FLIGHT CONTROLS - RUDDER TRIM AND FEEL MODIFICATION

700 Citation Longitude

MANDATORY**SB700-27-01****FLIGHT CREW OPERATIONS**

SB700-27-01
Page 1 of 2

Figure 1. Rudder Trim and Feel Assembly (Sheet 1)

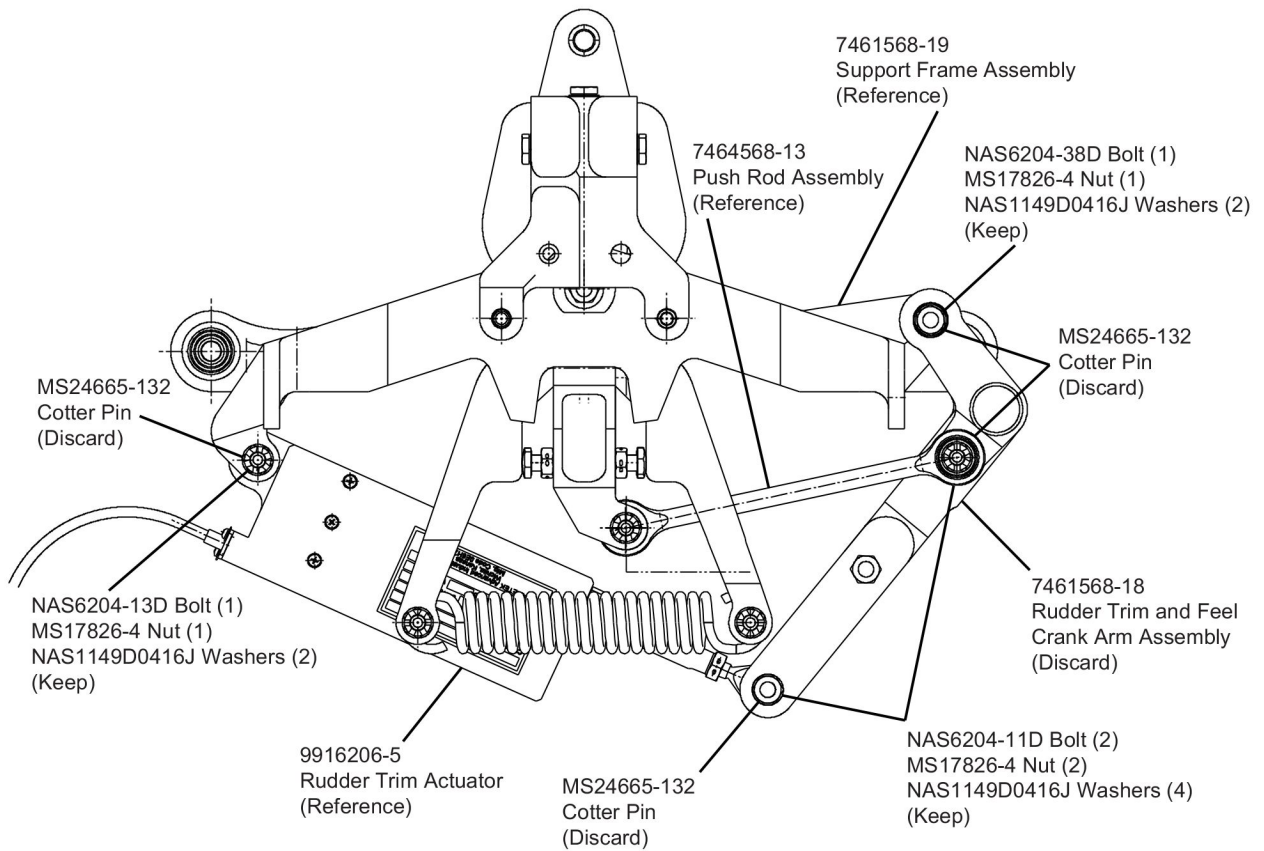
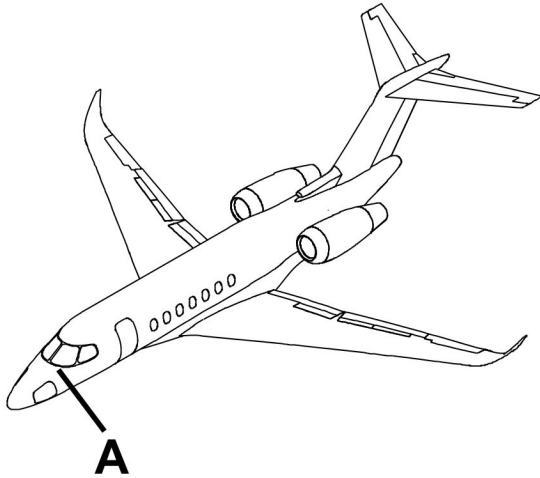
There is potential interference between the co-pilot left rudder pedal and the rudder trim and feel crank arm assembly when there is some left trim input, rudder pedals adjusted full forward, full left rudder and then a left brake application.

- A. (Refer to Figure 1, Sheet 1.) Remove the 7461568-18 Rudder Feel and Trim Crank Arm Assembly.
 - (1) Remove and discard the MS24665-132 Cotter Pin that attaches to the MS17826-4 Nut on the 7464568-13 Pushrod Assembly.

- (7) Remove and discard the MS24665-132 Cotter Pin that attaches to the MS17826-4 Nut on the 7461568-18 Rudder Trim and Feel Crank Arm Assembly.
- (8) Remove the NAS6204-38D Bolt, MS17826-4 Nut and NAS1149D0416J Washers that attach the 7461568-18 Rudder Trim and Feel Crank Arm Assembly to the 74661568-19 Support Frame Assembly and keep.

- (9) Remove the 7461568-18 Rudder Trim and Feel Crank Arm Assembly.
- B. (Refer to Figure 1, Sheet 2.) Install the 7496028-2 Rudder Trim and Feel Crank Arm Assembly.
